Addendum No. 2

1/30/25

College of Southern Idaho Leroy Craig Center

**PROJECT: LeRoy Craig Jerome Center
College of Southern Idaho
Jerome, Idaho**

DRAWING NO.
SD7.0
UTILITY PLAN

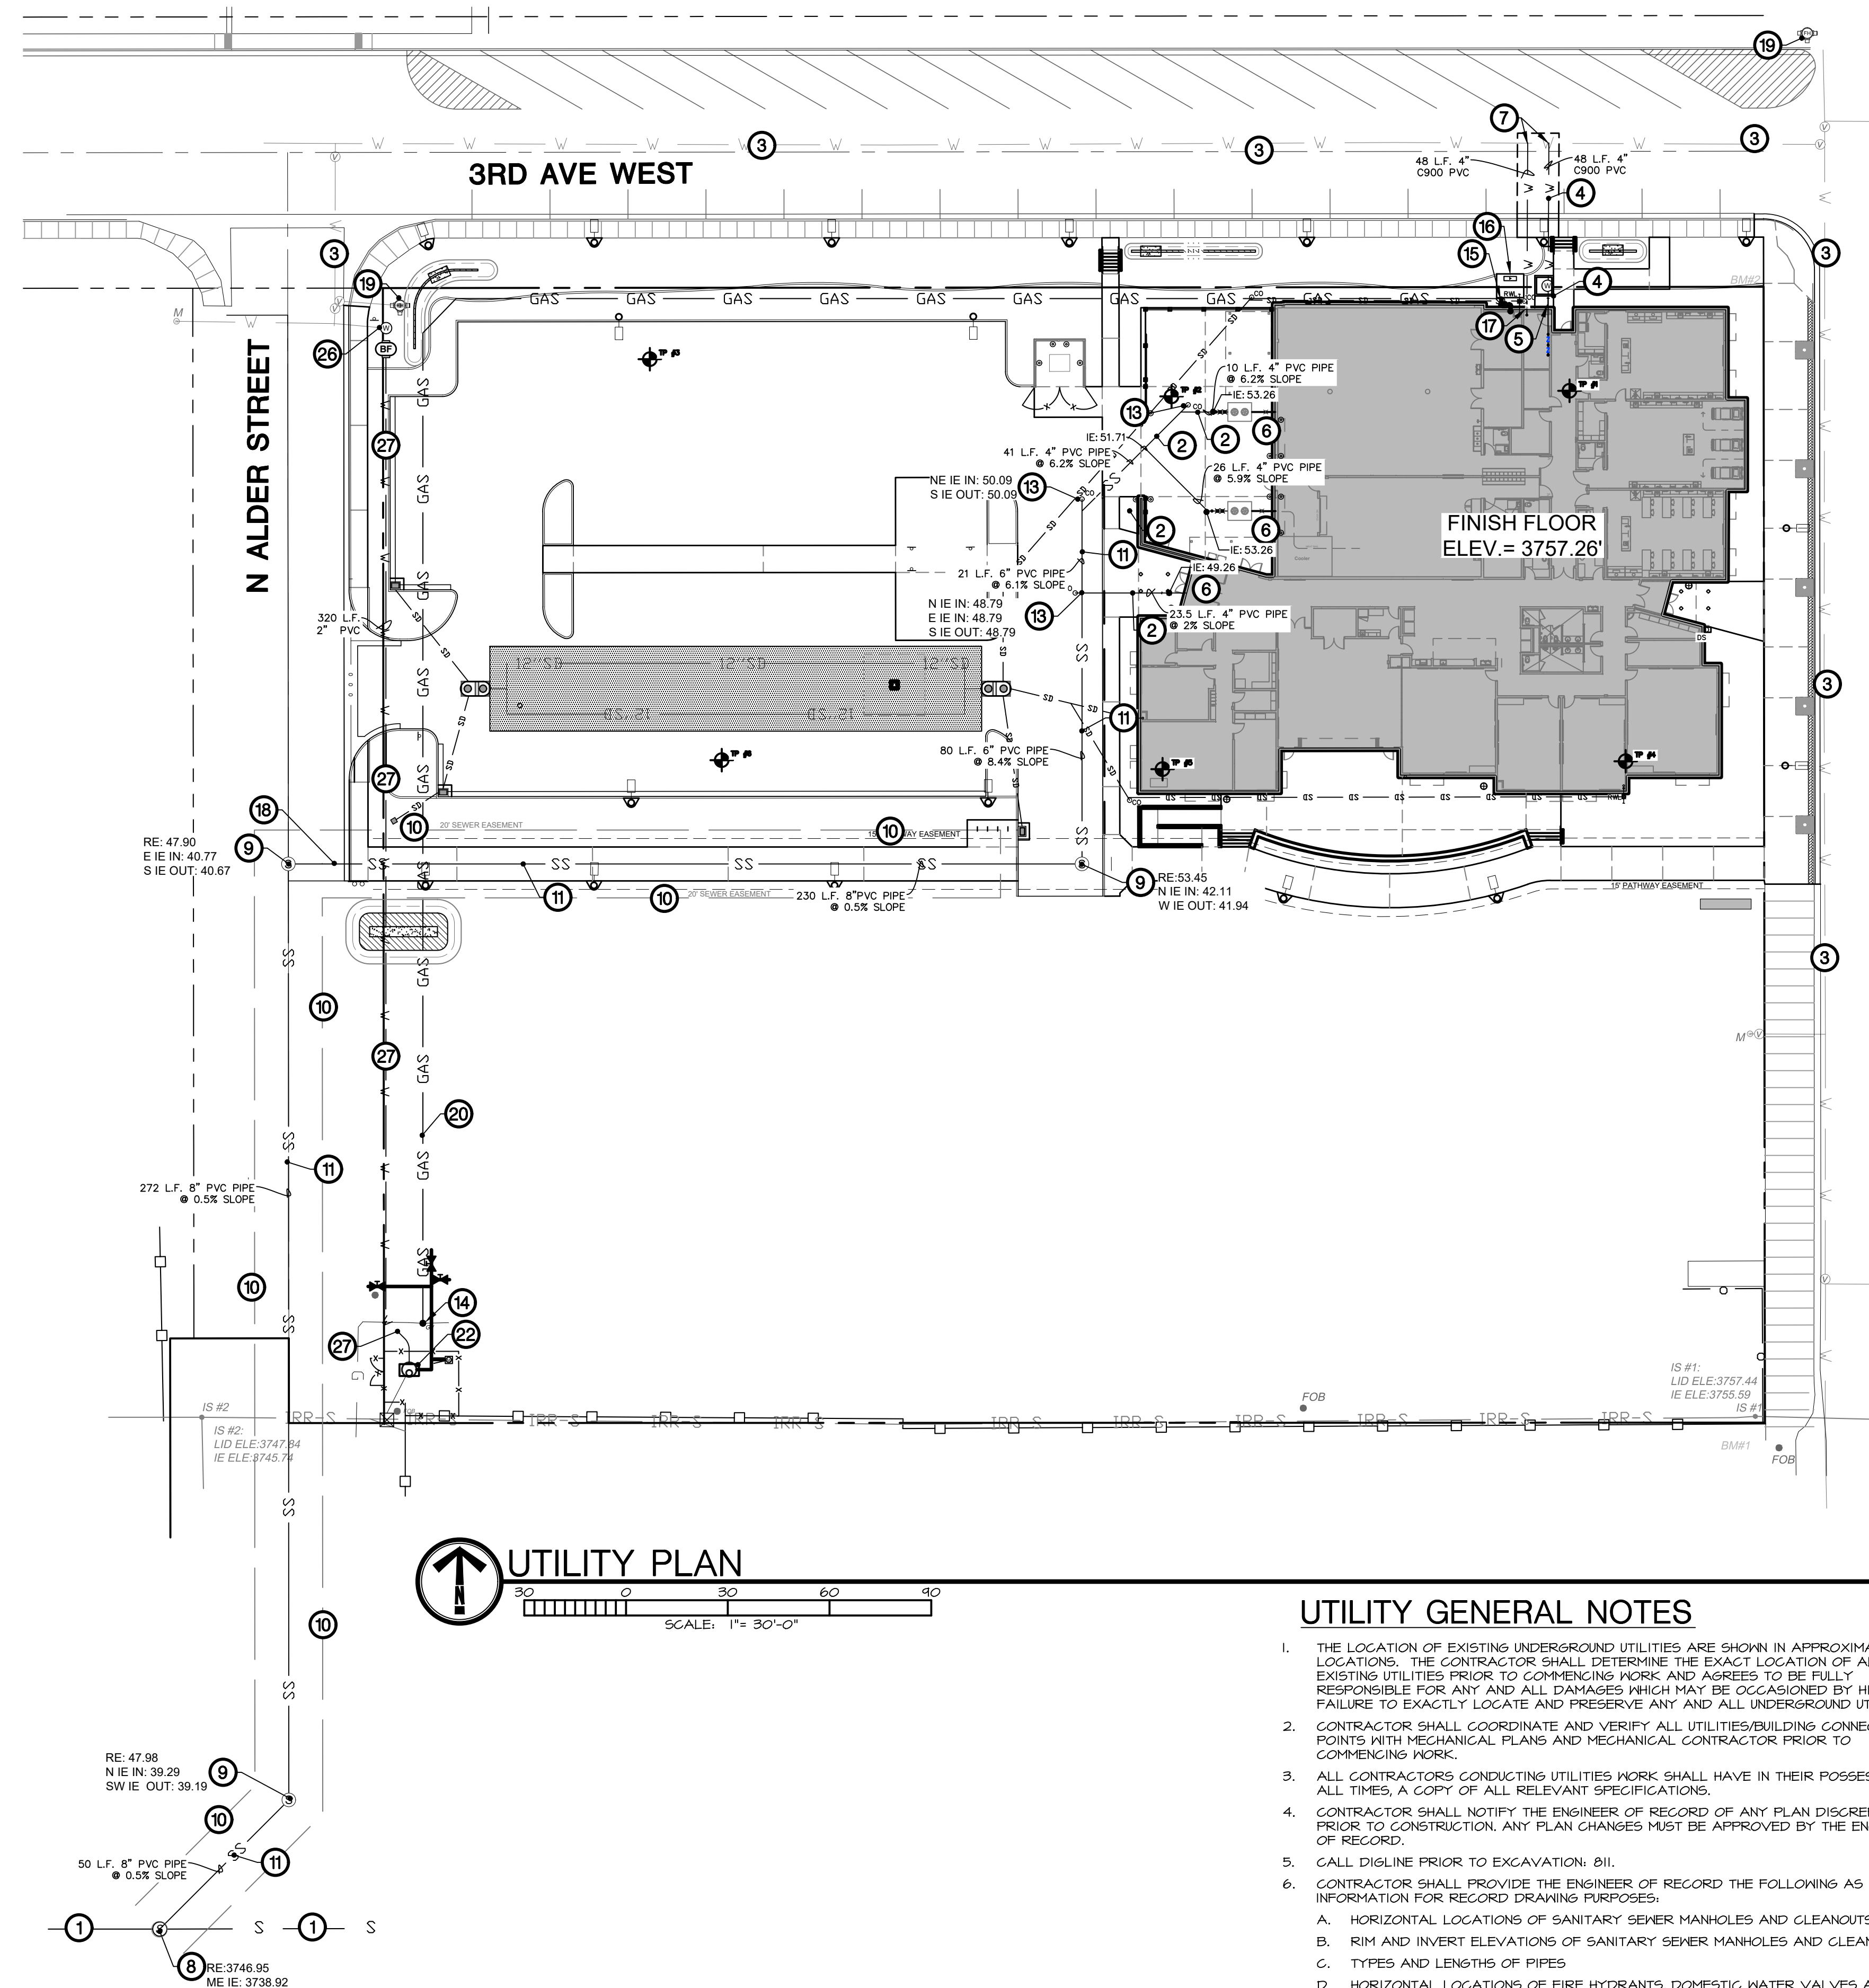
- 1-8 Sheet SD3.0, Add callout 27, Steel Bollard locations.
- 1-9 Sheet SD3.5, Delete detail 9.
- 1-10 Sheet SD7.0, Replace sheet, per attached.
- 1-11 Sheet SD7.0 Replace callout 12 with "not used".

- 1-12 Sheet SD7.5, Add sheet with sewer profile and water meter vault detail.
- 1-13 Sheet SL1.0, Revise tree locations along Lincoln for adjusted tree grate locations.

DRAWING NO.
SL10
LANDSCAPE PLAN

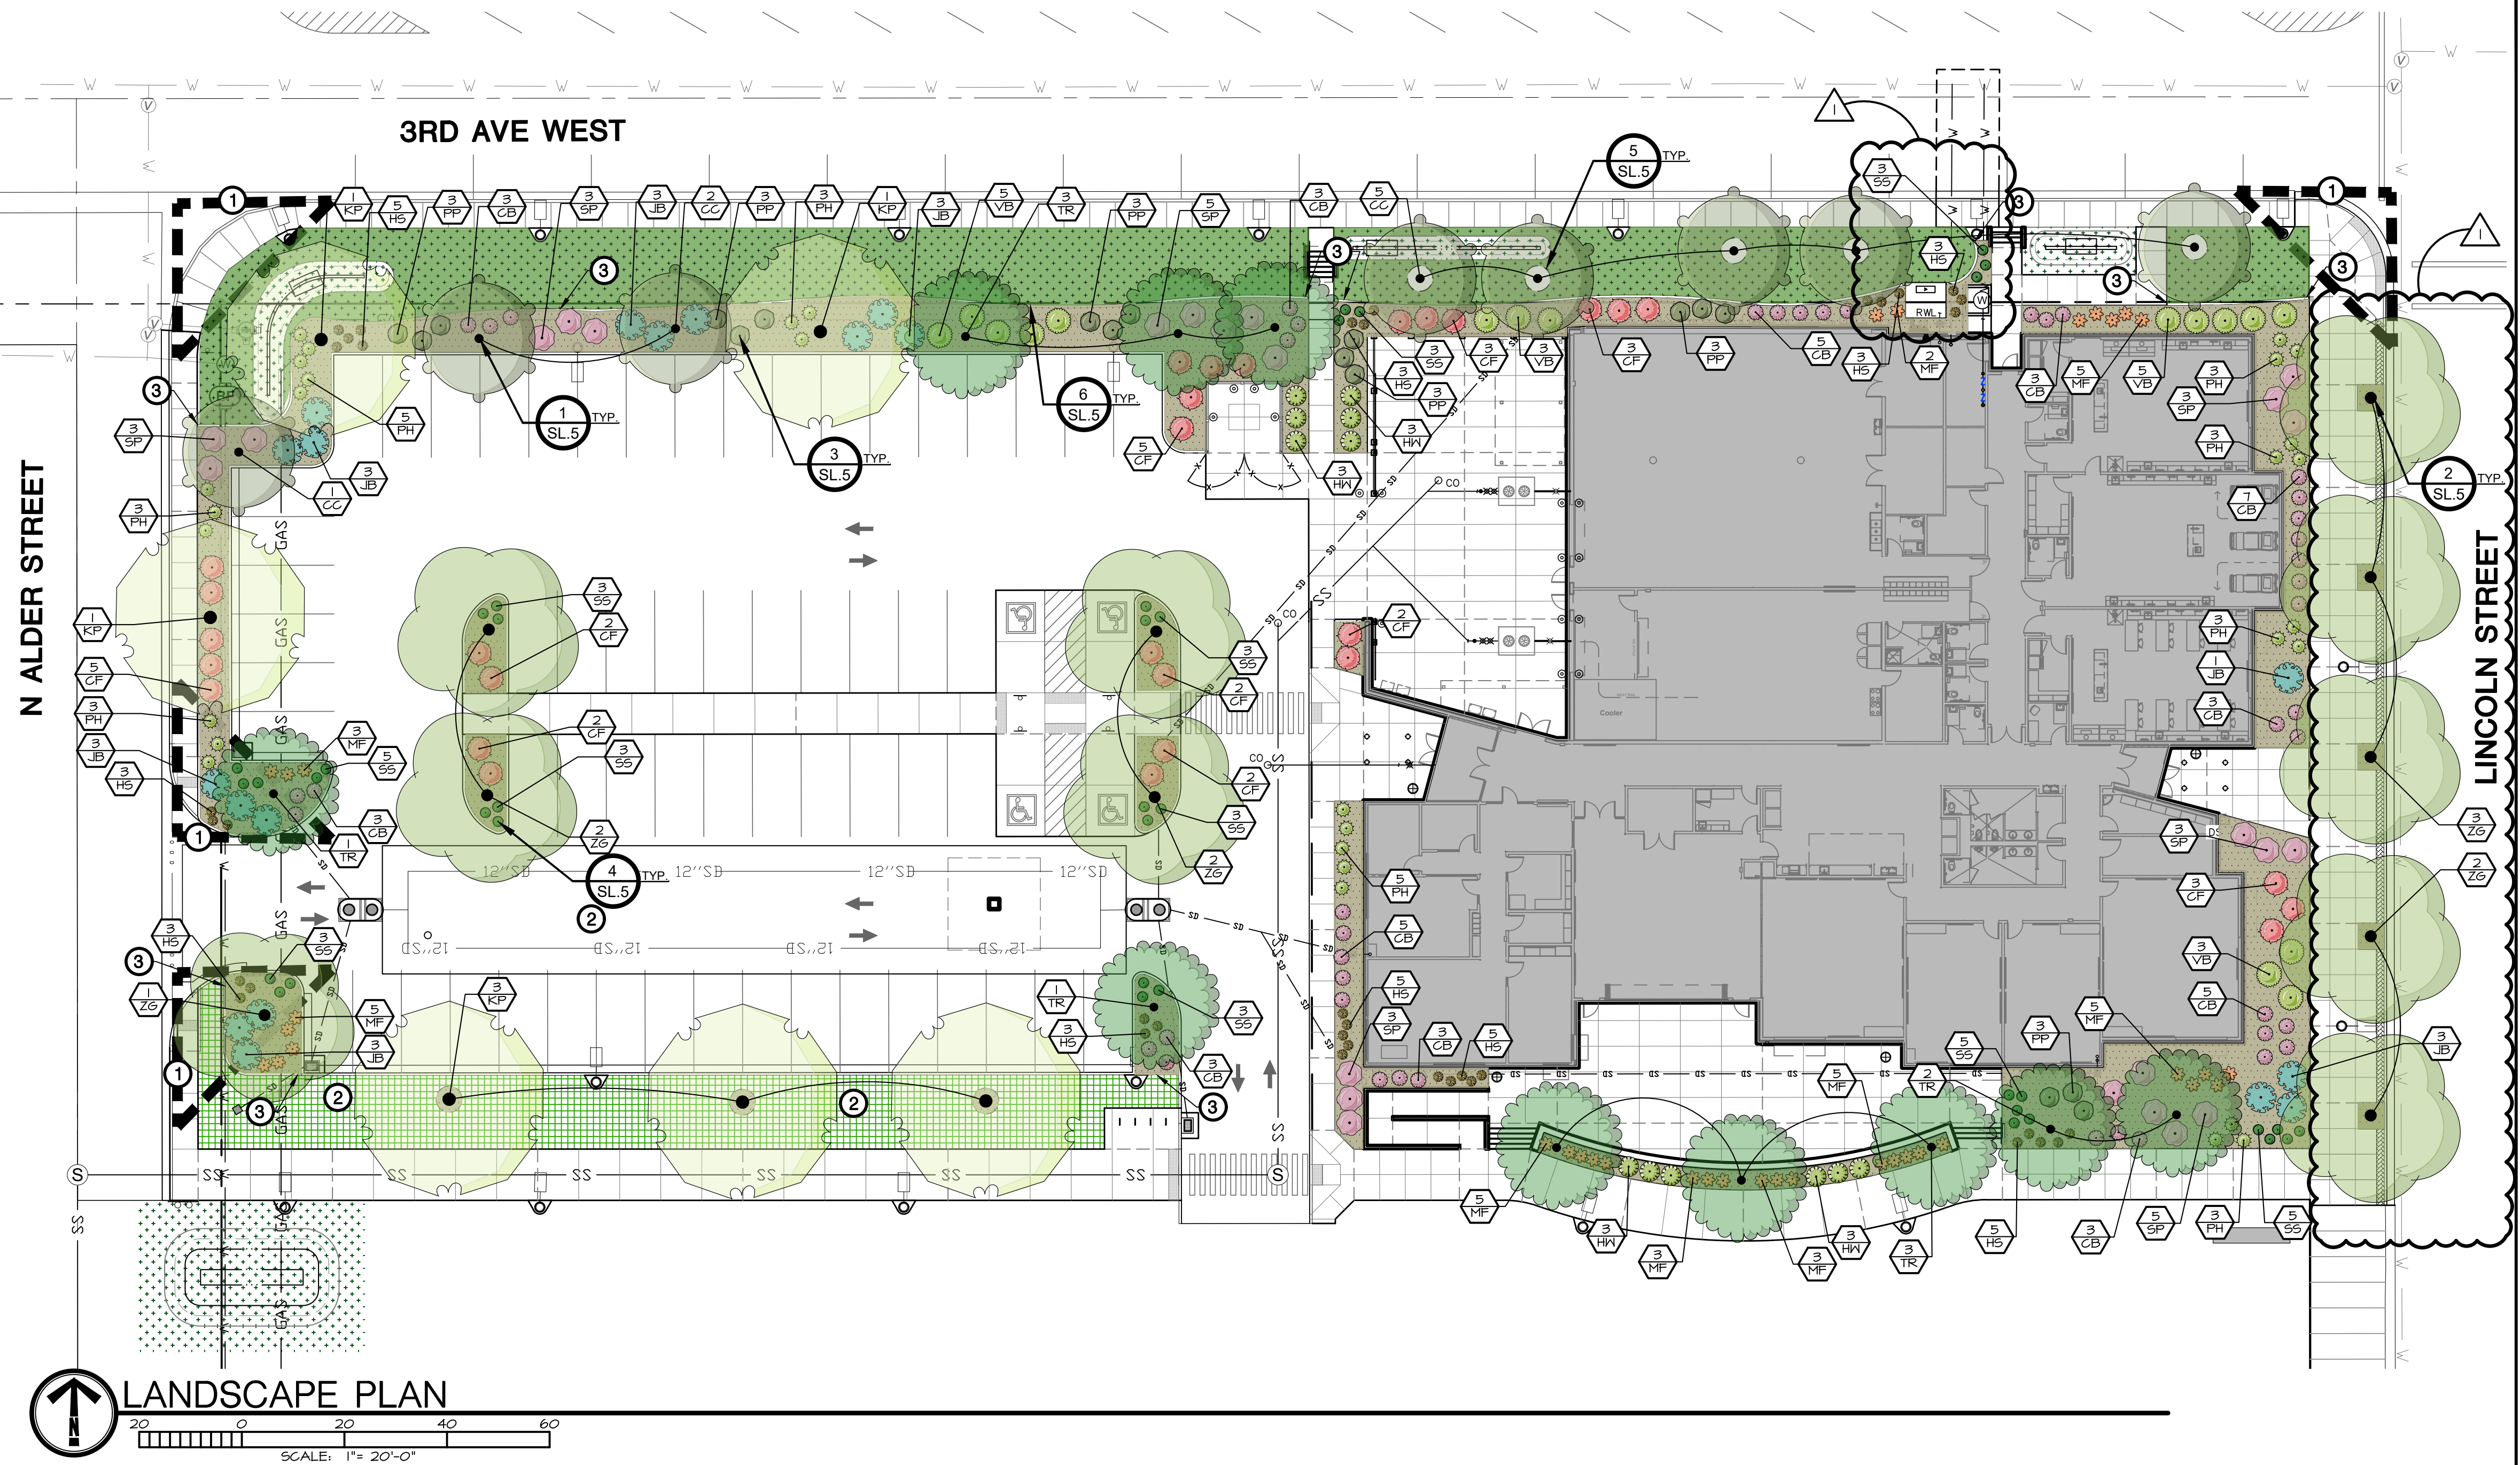
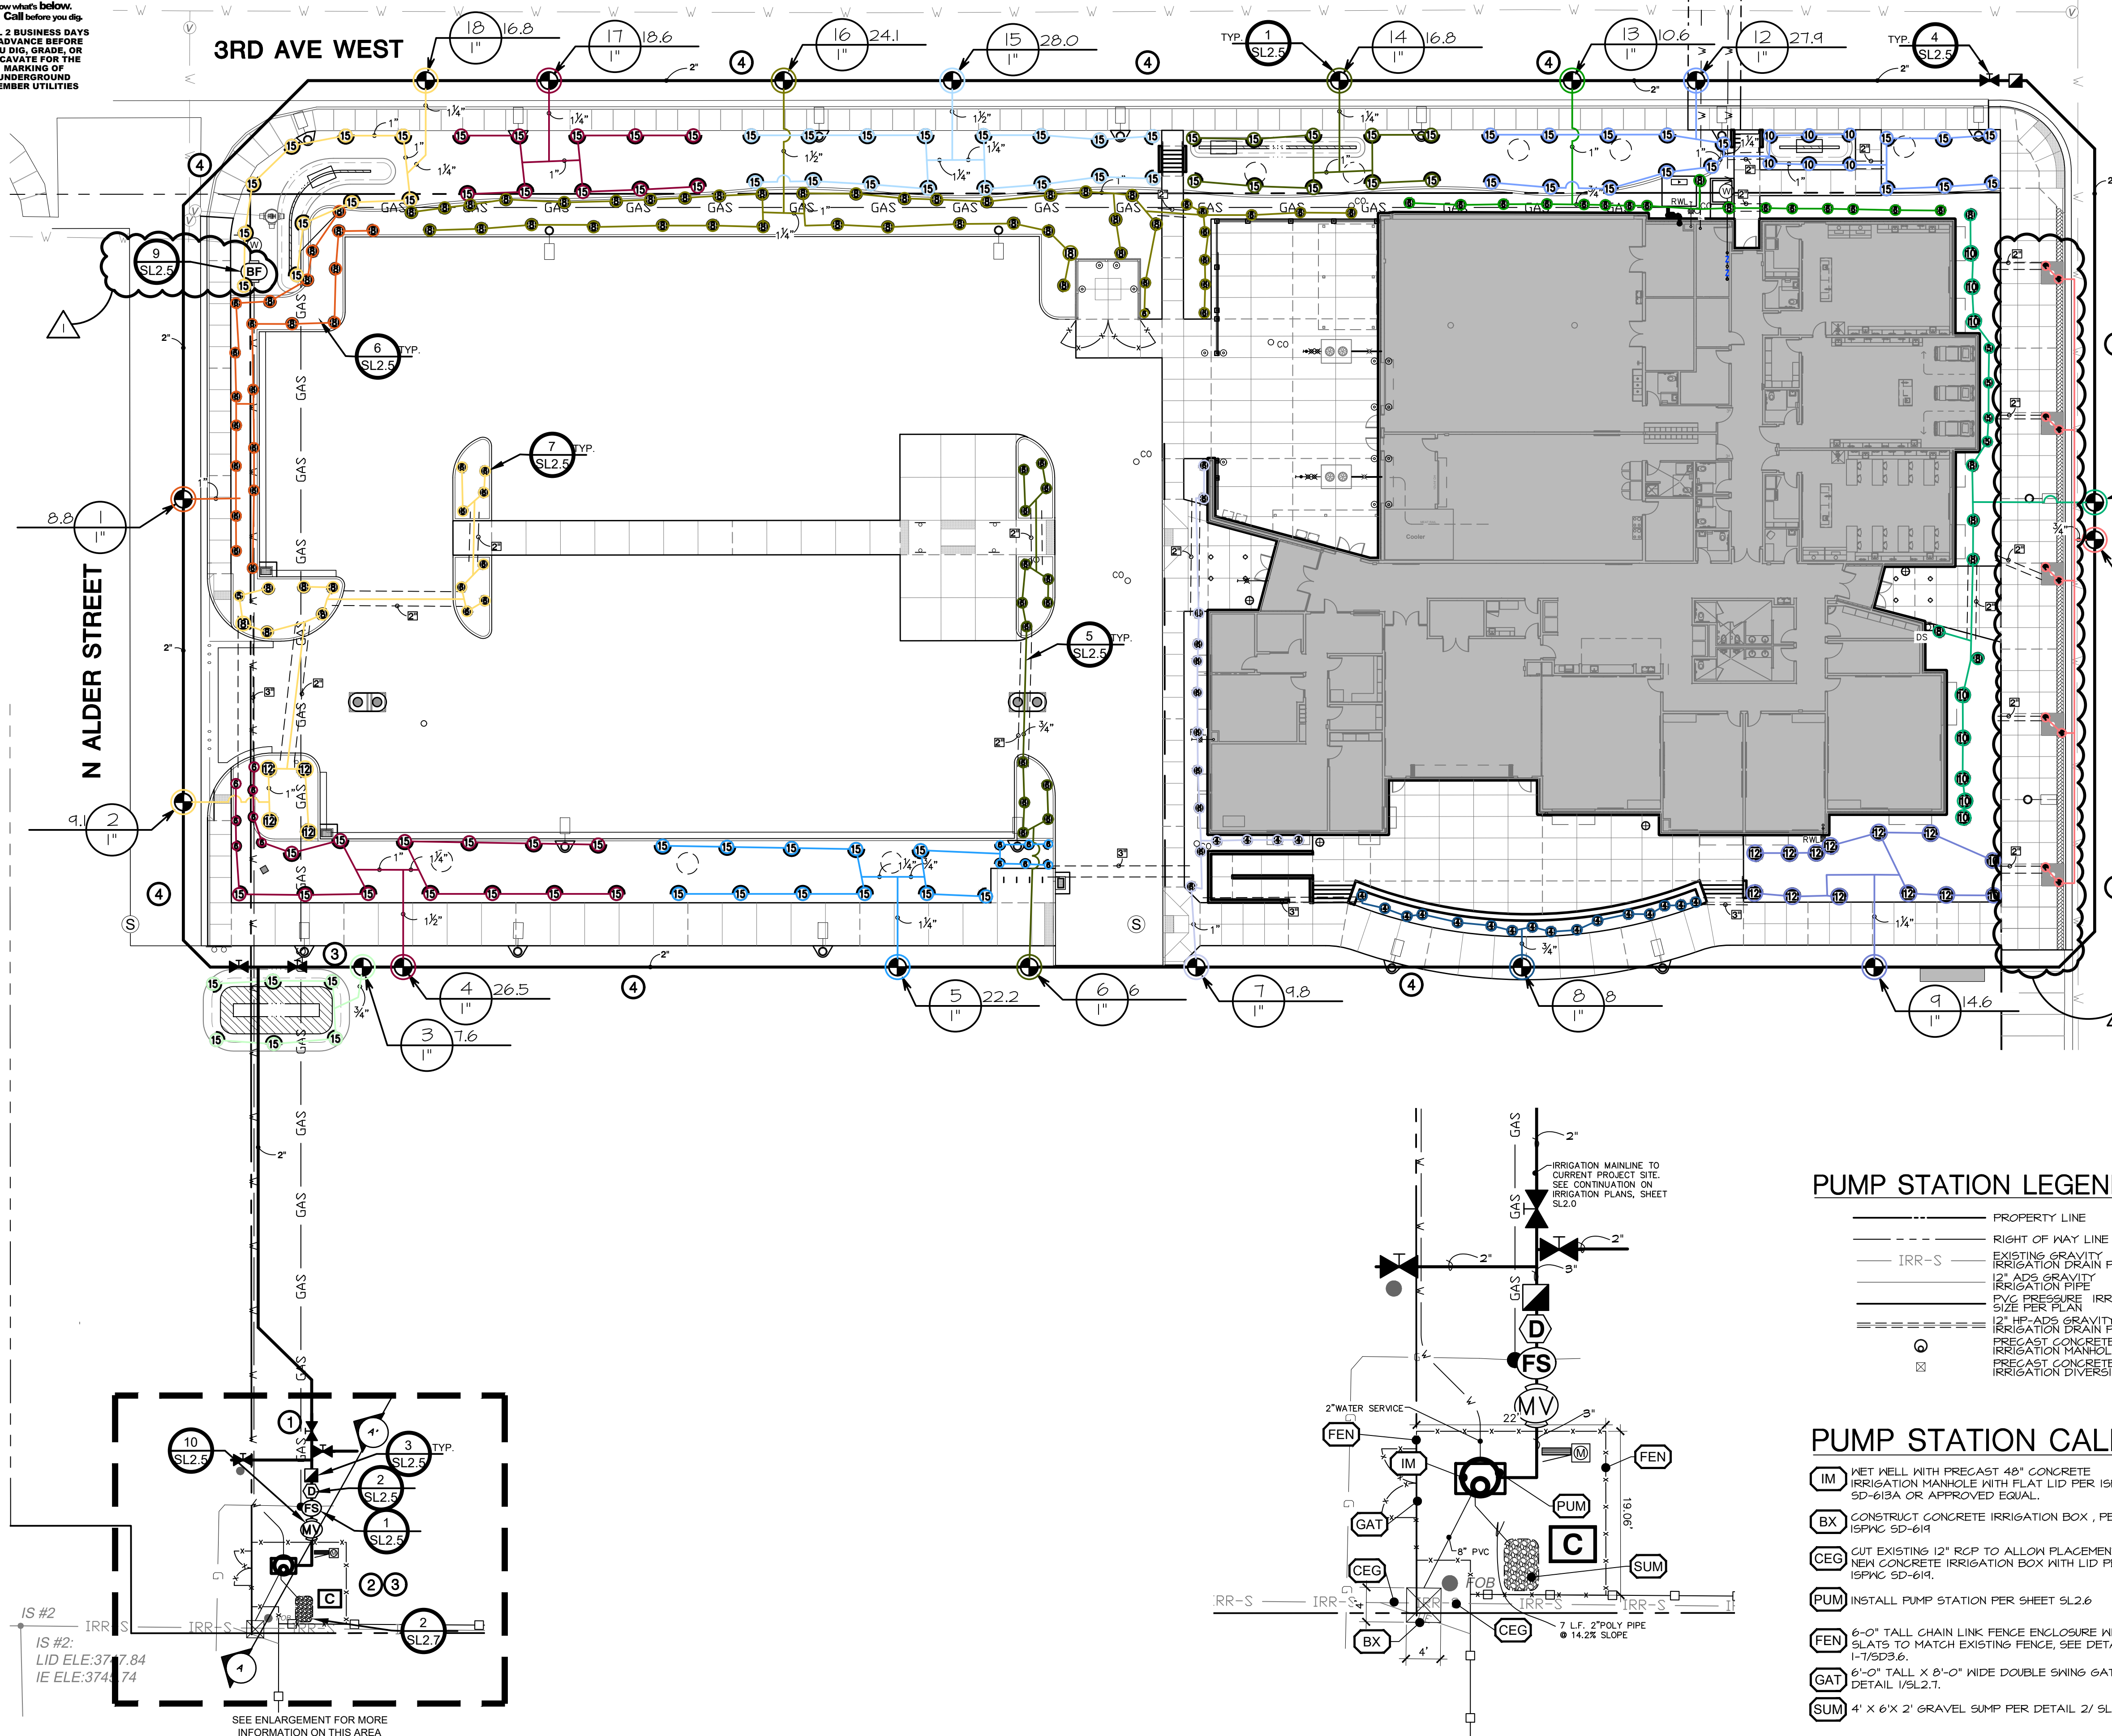
- 1-14 Sheet SL1.0, Revise plant locations around water meter vault.
- 1-15 Sheet SL2.0, Revise irrigation schedule valve sizes.
- 1-16 Sheet SL2.0, Revise drip irrigation location at tree grate locations.
